SSD 7056: RESPONSE TO SUBMISSIONS

CAMPBELL'S STORES, THE ROCKS

Director	Jennifer Cooper
Senior Consultant	Samantha Wilson
Project Code	SA5710
Report Number	Response to Submissions - October 2016

Figure 1 – Bay 12 Site Plan

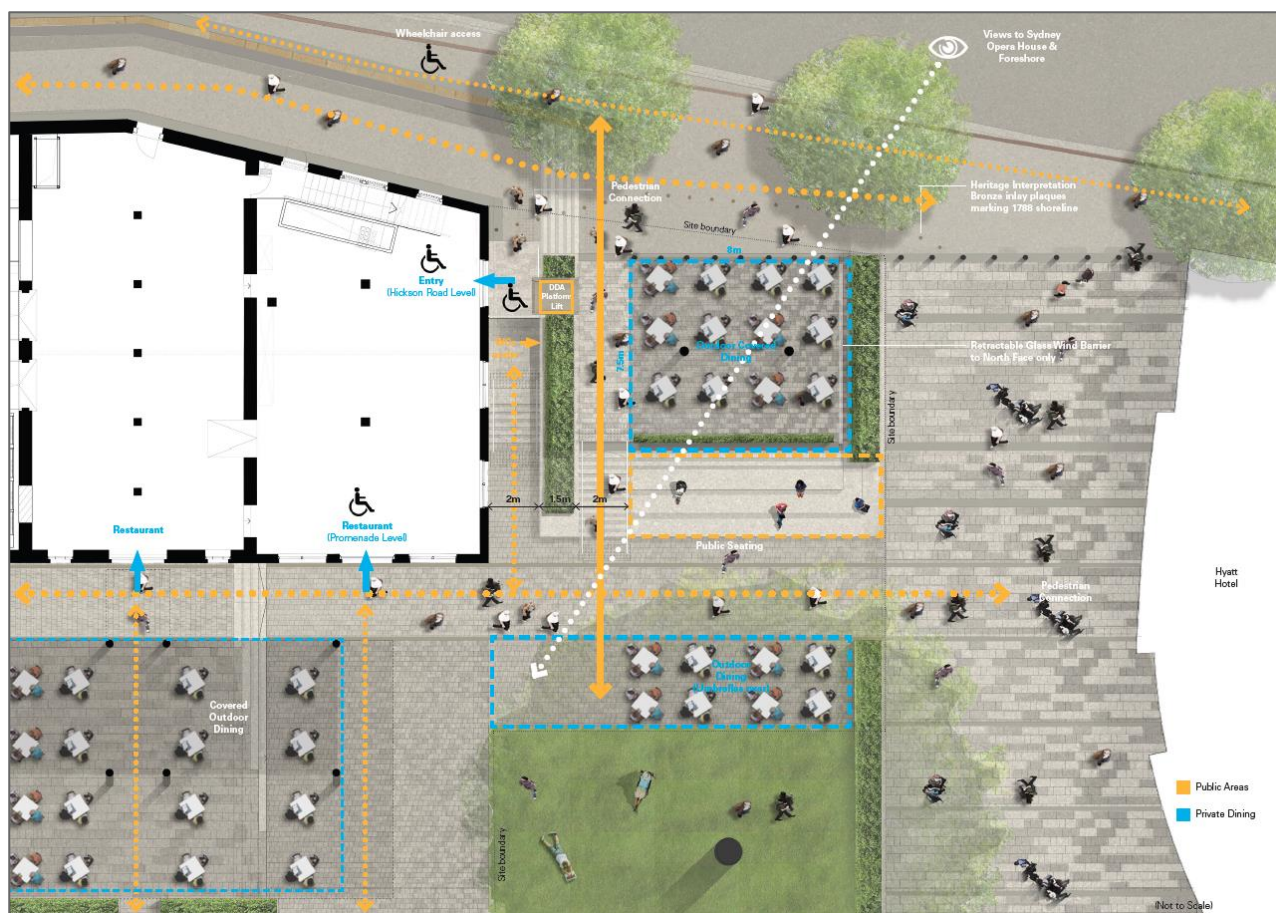
In response to the concerns raised by the Minister for Heritage, as well as the independent expert heritage and design advice and public submissions, the proposed free standing 'Bay 12' building has been removed from the application.

In response to the agency and public submissions received, as well as the independent expert heritage and design advice, the free standing 'Bay 12' building has been removed from the application. The 'Bay 12' area has been redesigned to accommodate a landscaped oriented proposal, set within the existing statutory planning framework, and comprises the following key elements:

The Bay 12 proposal provides a new 2 metre wide through-site link along the northern elevation of Bay 11. The link will provide a new public access route connecting Hickson Road with the Campbell's Cove promenade and Sydney Harbour. The link also provides improved visual connectivity from Hickson Road to Sydney Harbour and the Opera House.

Figure 4 – Dimensions of proposed planter boxes

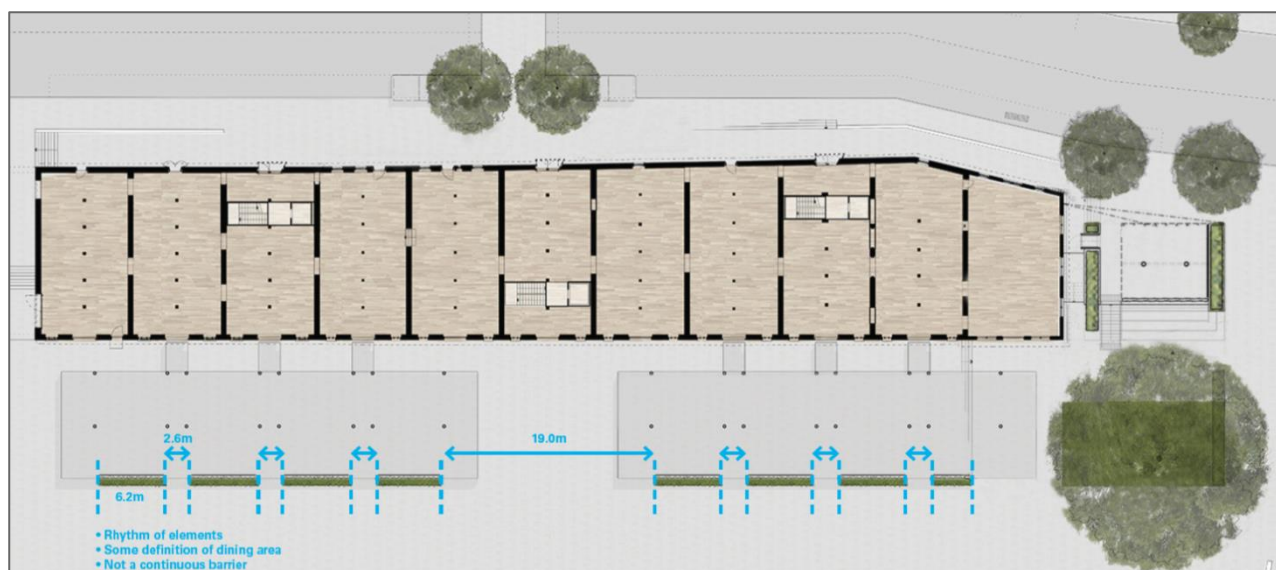
The submission echoes the Heritage Council's original concern regarding the proposed planter boxes and retractable wind barriers within the waterfront outdoor dining area. Specifically, the submission states:

"The Heritage Council would like to reiterate the importance of maintaining a clear visual connection between Campbell's Stores and the waterfront by avoiding any permanent, delineating elements. The proposed moveable planter boxes will not achieve this objective. It is considered that the planter boxes should be deleted altogether to allow the foreground of Campbell's Stores to be read as a continuous open space."

- The planter boxes provide clear delineation between the public domain and the outdoor dining area.
- The planter boxes are not a continuous barrier. The planter boxes are designed as eight separate elements that comprise of three 2 metre long modules. Each section is separated by a 2.6 metre passage way, which aligns with each of the heritage doorways and function as restaurant entrances (refer Figure 4).
